Access Compliance Report

Public Rights-of-Way

Intersection ID: 50589	Main Street: BENDING_BRANCH_RD	Cross Street: GREEN_GRASS_RD	Location: W
ADA ID: 10A10419691A	Ramp Type: Perp	Initial Pass/Fail: Fail	Overall Compliance: No
		Severity Score: 10

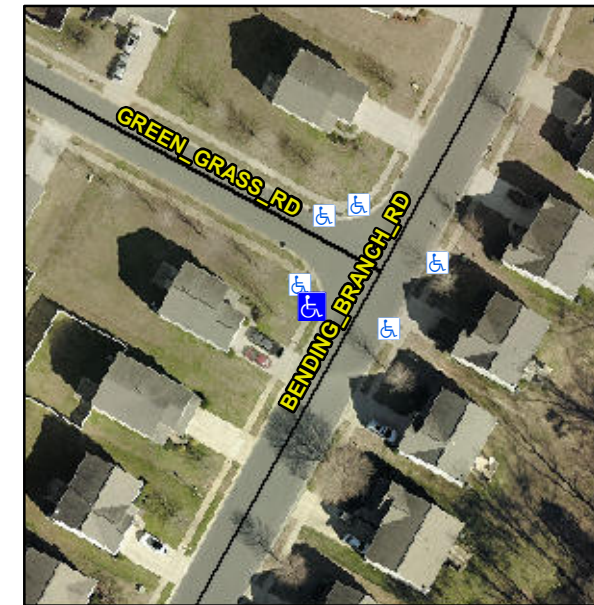
Not Found, R304.5.1, R304.5.3

Compliance	Description	Data	Compliance	Description	Data
N/A	Ramp Length (in)	48.0	Yes	Ramp Slope (%)	6.2
No	Ramp Width (in)	47.5	No	Ramp XSlope (%)	2.2
N/A	Flare Type LT	N/A	N/A	Flare Type RT	N/A
N/A	Flare Slope LT (%)	N/A	N/A	Flare Slope RT (%)	N/A
N/A	Flare Traversable LT?	N/A	N/A	Flare Traversable RT?	N/A
N/A	Landing Length (in)	N/A	N/A	DWS Provided?	N/A
N/A	Landing Width (in)	N/A	N/A	DWS Contrast?	N/A
N/A	Landing Slope (%)	N/A	N/A	DWS Length (in)	N/A
N/A	Landing X Slope (%)	N/A	N/A	DWS Full Width?	N/A
N/A	Landing Curb? (Y/N)	N/A	N/A	DWS Offset (in)	N/A
N/A	Shared Landing?	N/A			
N/A	Gutter Ponding?	N/A	N/A	Gutter Slope (%)	N/A
N/A	Gutter Lip Ht (in)	N/A	N/A	Gutter X Slope (%)	N/A
N/A	Painted X Walk1?	No	N/A	Painted X Walk2?	N/A
	X Walk 1 Direction	To SE		X Walk 2 Direction	N/A
N/A	X Walk 1 Width (in)	N/A	N/A	X Walk 2 Width (in)	N/A
	X Walk 1 Slope (%)	3.5		X Walk 2 Slope (%)	N/A
	X Walk 1 X Slope (%)	1.4		X Walk 2 X Slope (%)	N/A

Remove & Replace Entire Ramp.
